AGENDA
PARKS, RECREATION & NATURAL RESOURCES COMMITTEE
MEETING

To: Planning Commission
From: Frank Dempsey, AICP, Associate Planner
Date: July 12, 2024
Subject: Packet Material for the July 18, 2024 Planning Commission Meeting

Ryan Sailer, representing Timberland Partners, Inc. has submitted applications and plans for a preliminary plat, final plat, and conditional use permit for Sundance Lakeville Second Addition, which proposes one lot and one block with 13 townhome buildings and 167 dwelling units and nine single family home lots with rental homes all totaling 15.75 acres north of 162nd Street (CSAH 46), west of Buck Hill Road and east of Kendale Avenue.

LANDSCAPE PLAN - VIEW 2

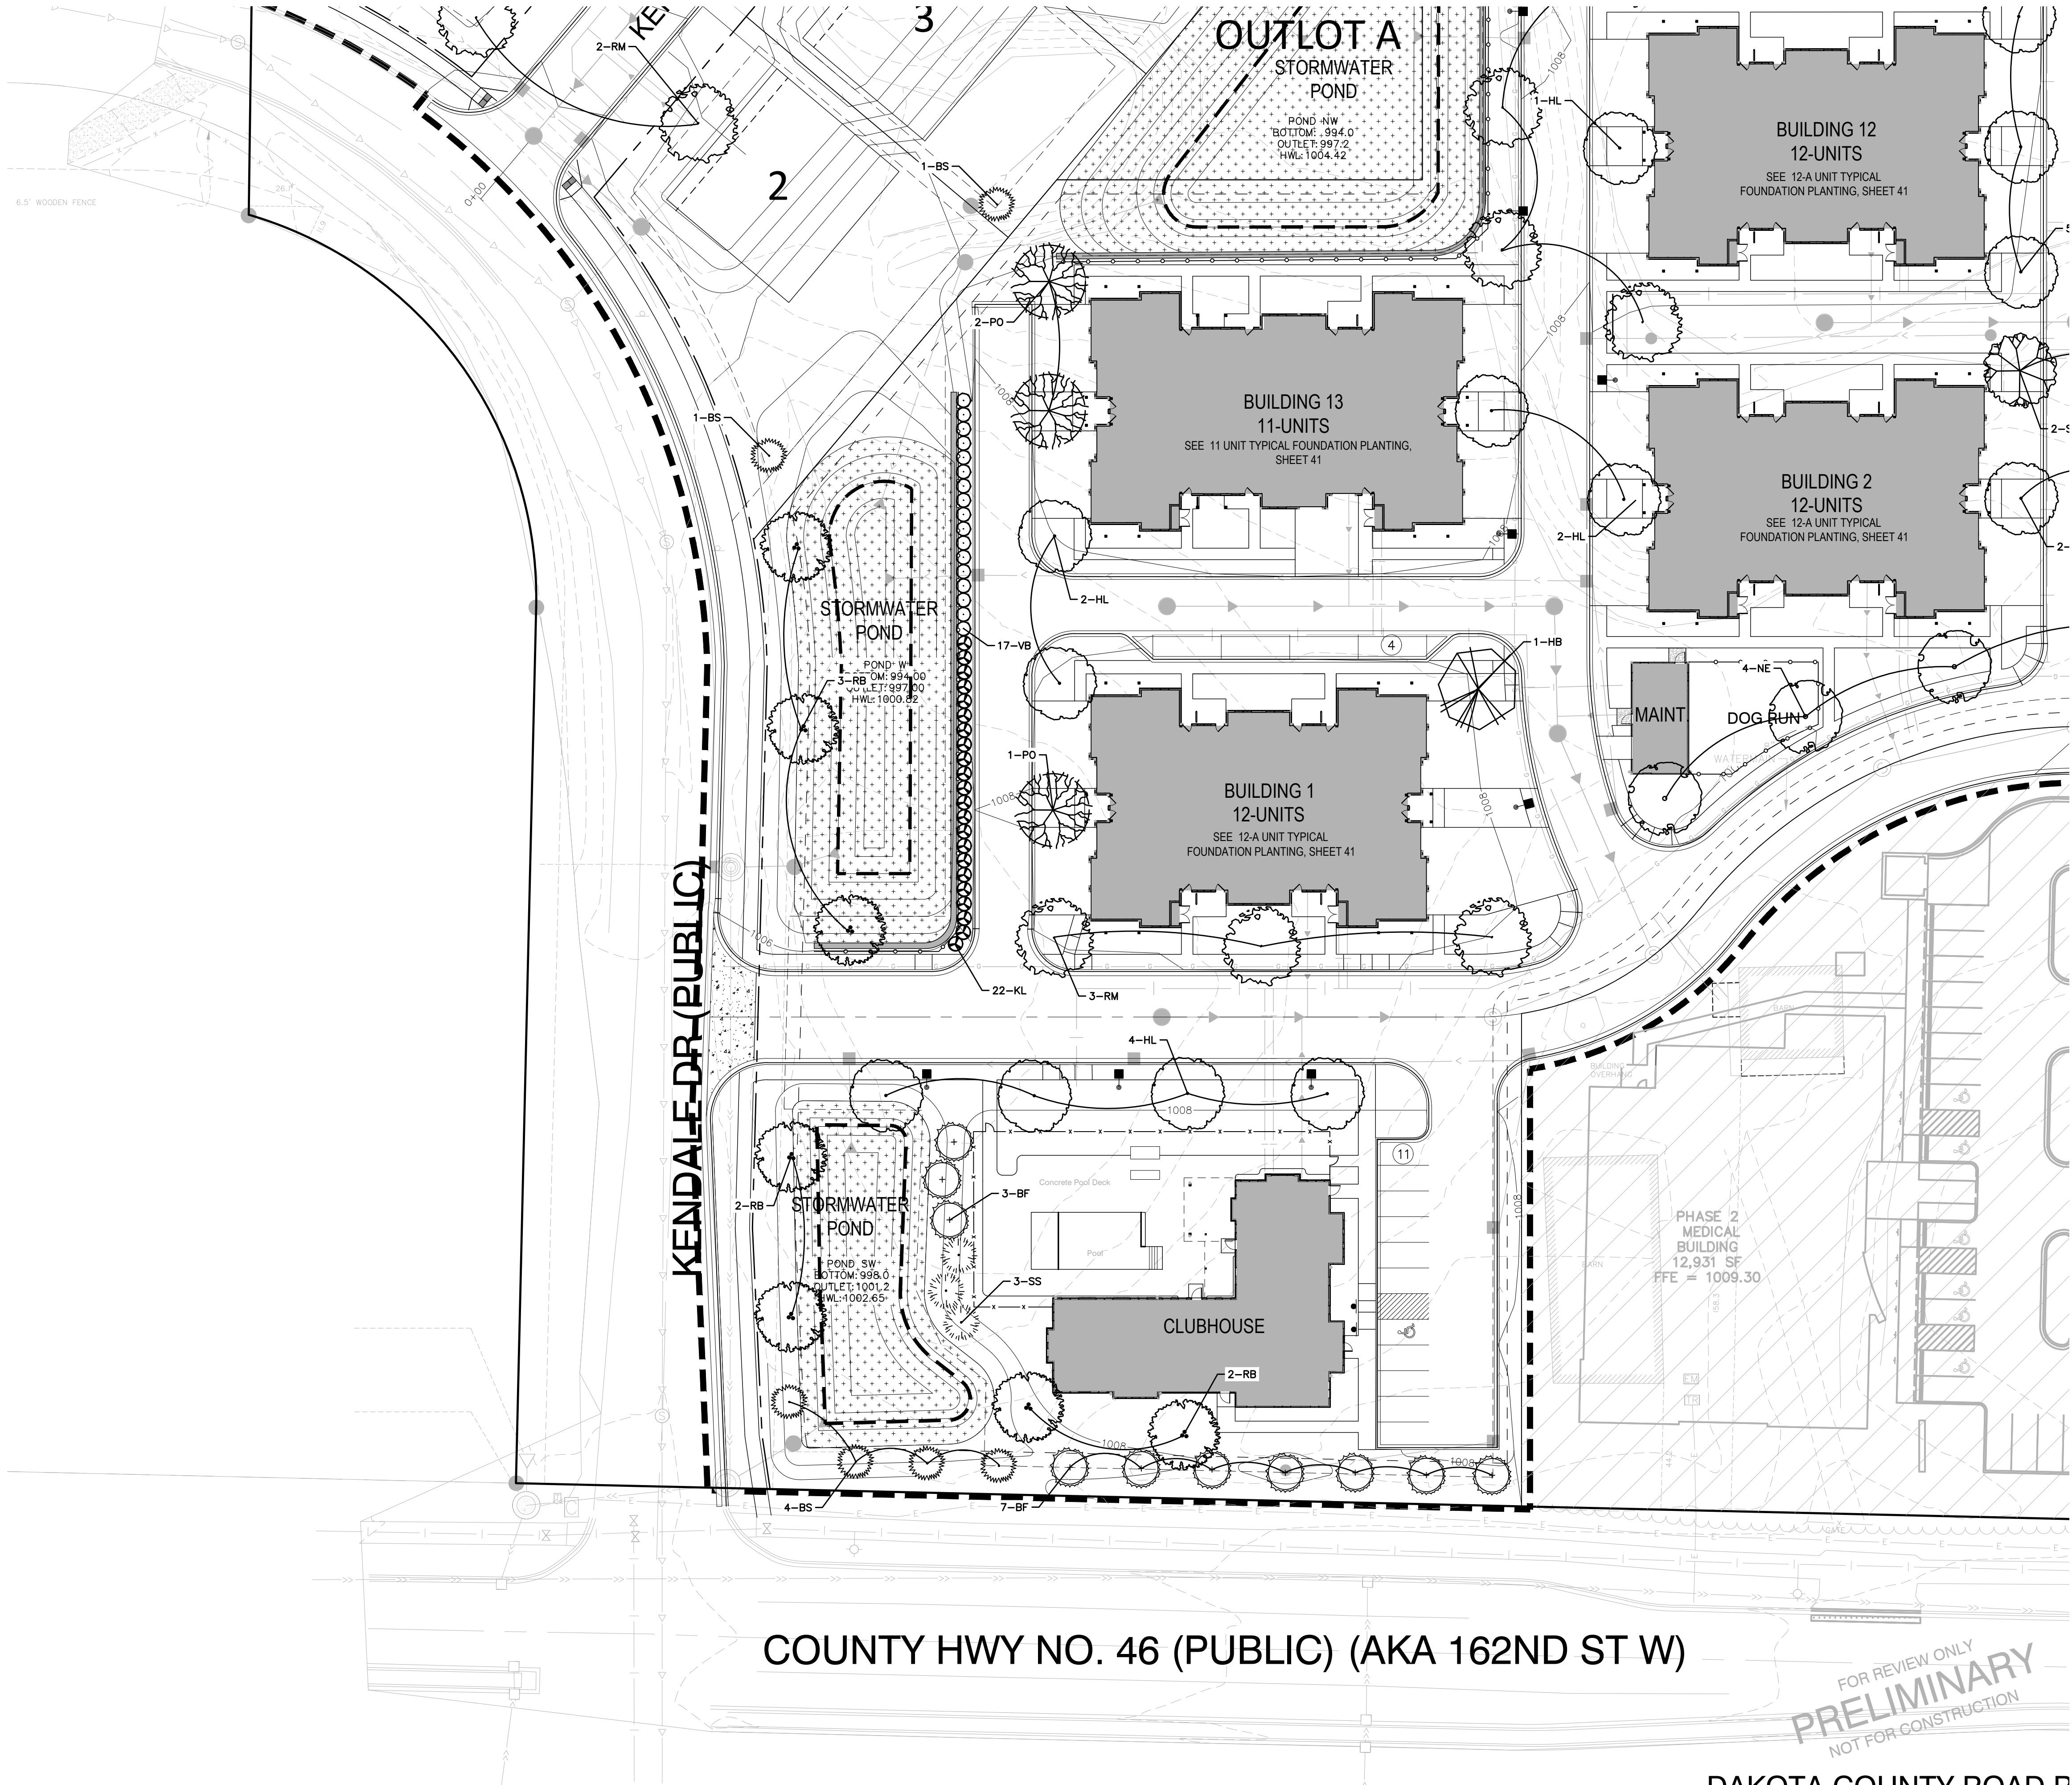
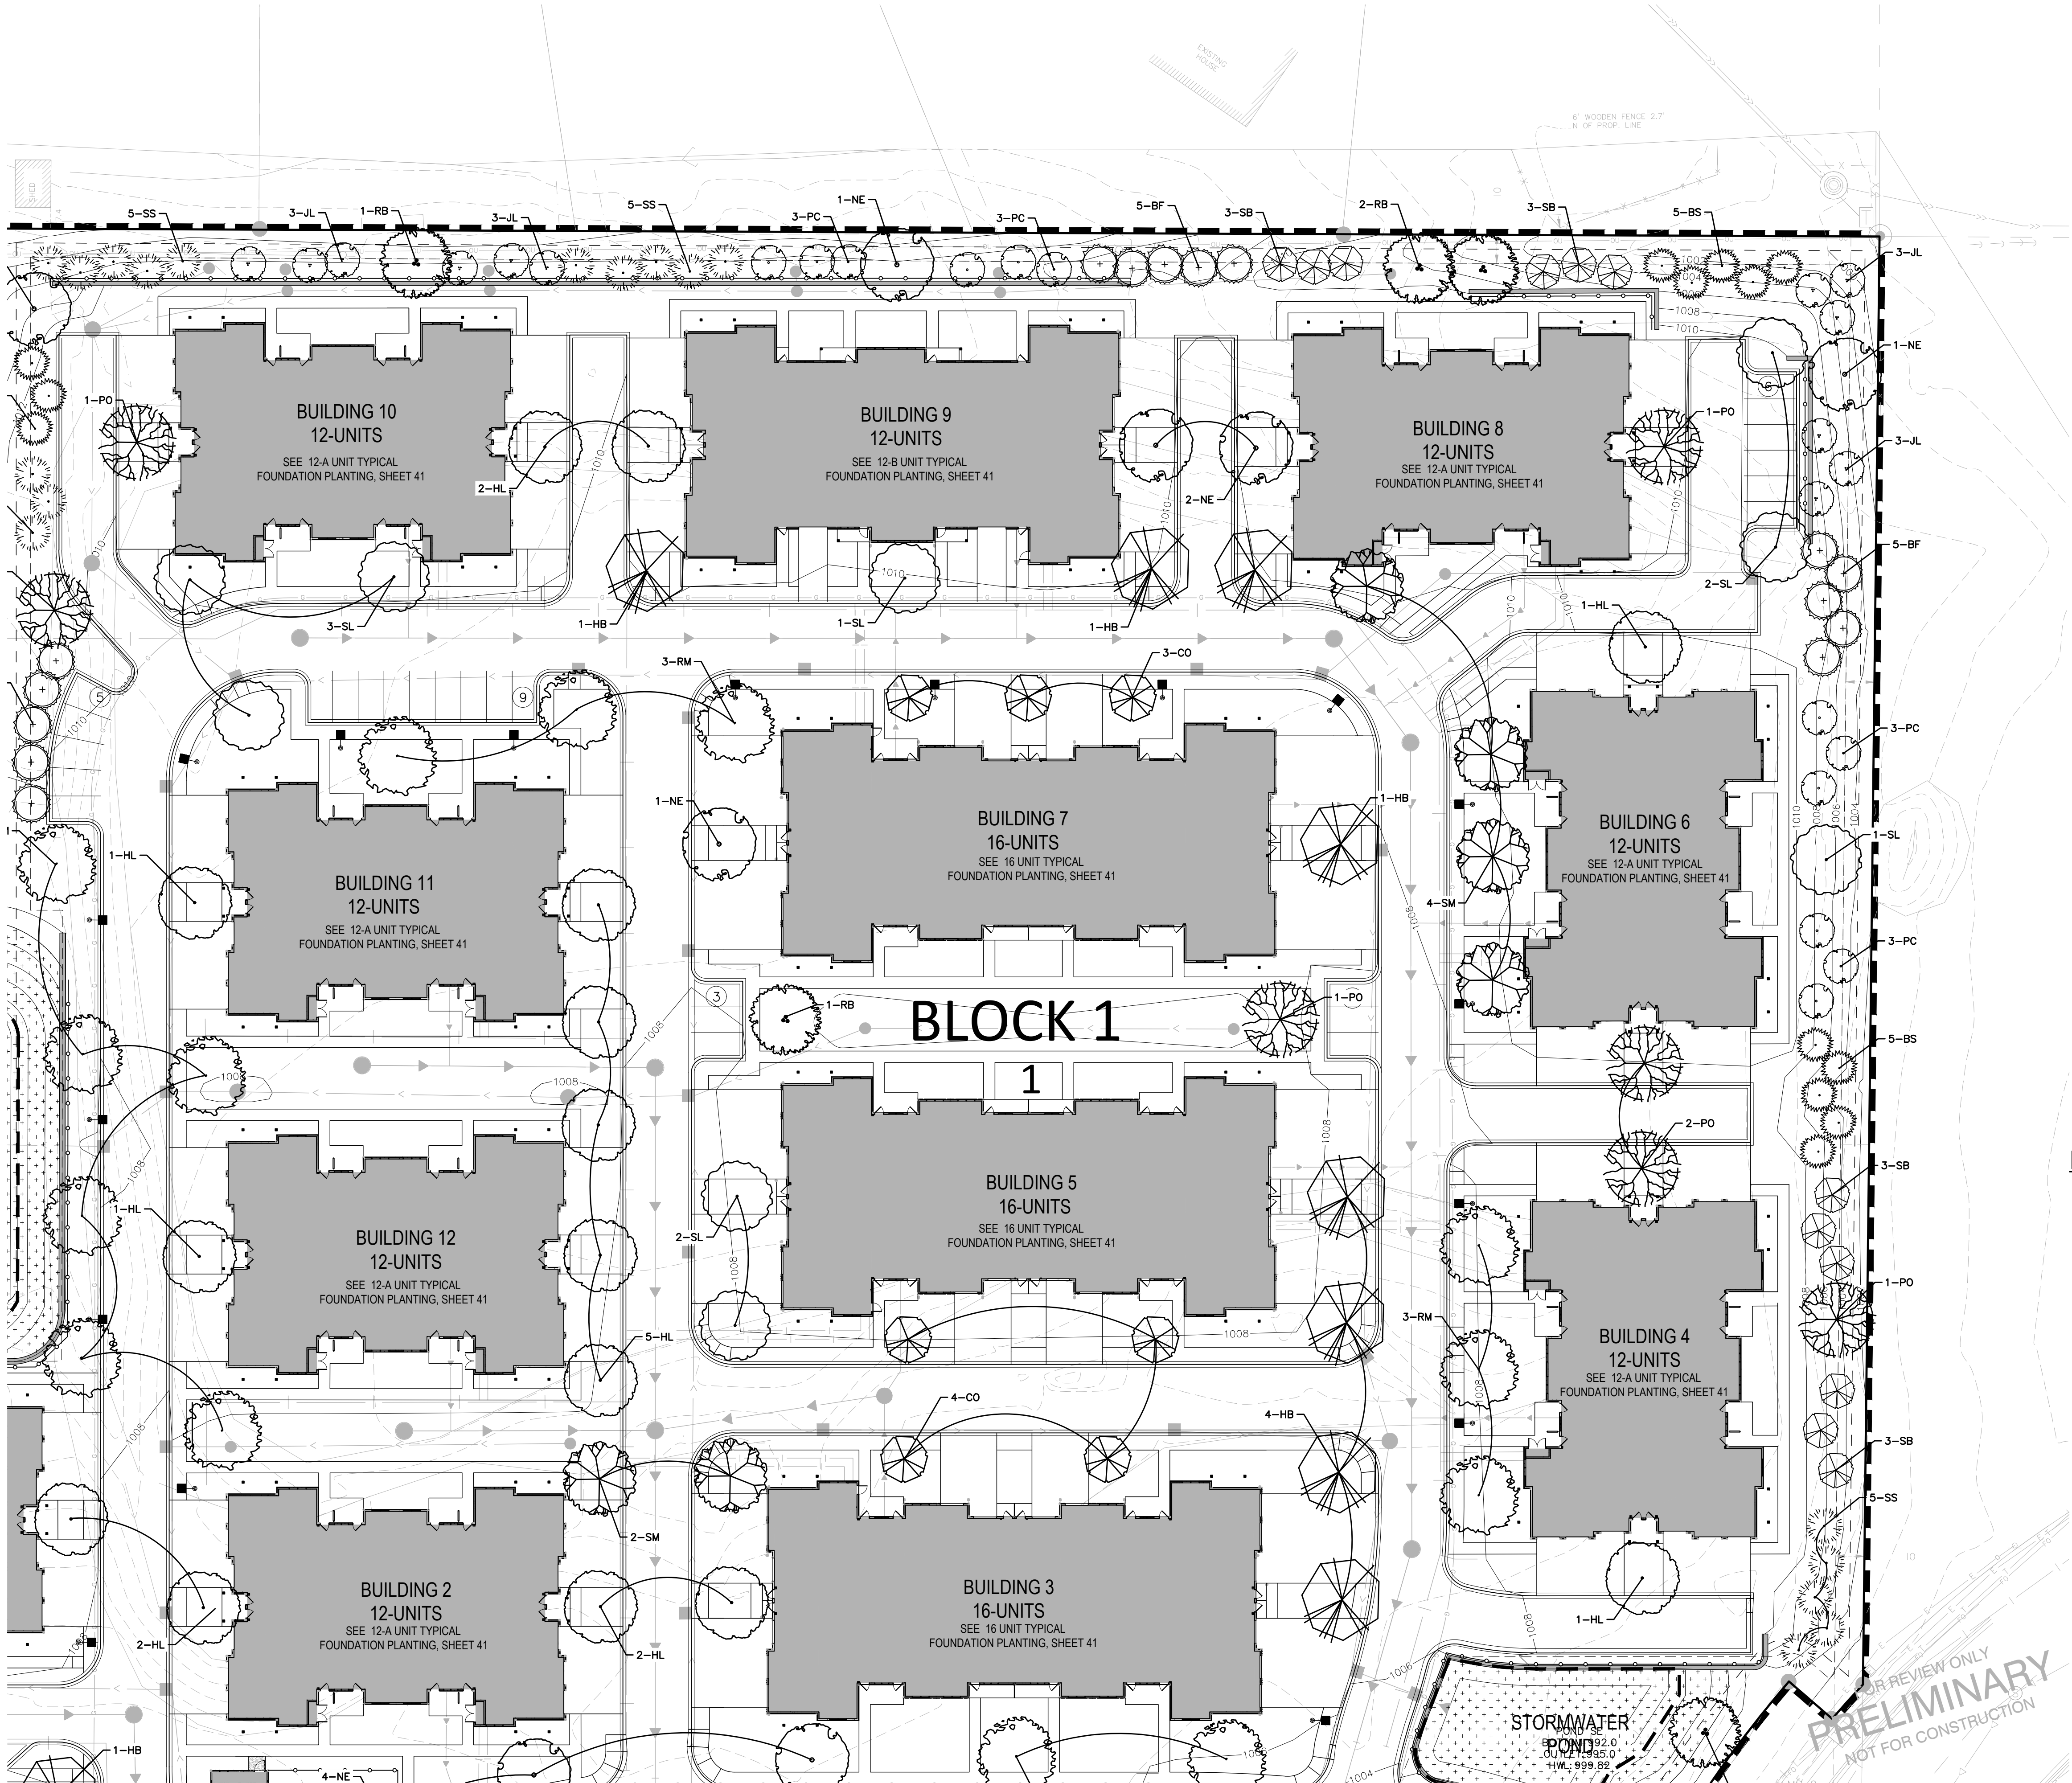
The site and landscape plan propose a minimum 30-foot landscaped buffer between the townhome property and the single-family homes to the north. A 30-foot landscaped buffer is consistent with the 30-foot required landscaped buffer between single family homes and commercial zoned property. The landscape plan design along the north boundary of Lot 1 shall be amended to include a row of evergreen trees planted south of the utility easement to provide additional year-round screening of the townhome buildings from the north.

3. Park dedication must be paid at the time of final plat approval.
4. The landscape plan design along the north boundary of Lot 1 shall be amended to include a row of evergreen trees planted south of the utility easement to provide additional year-round screening of the townhome buildings from the north.
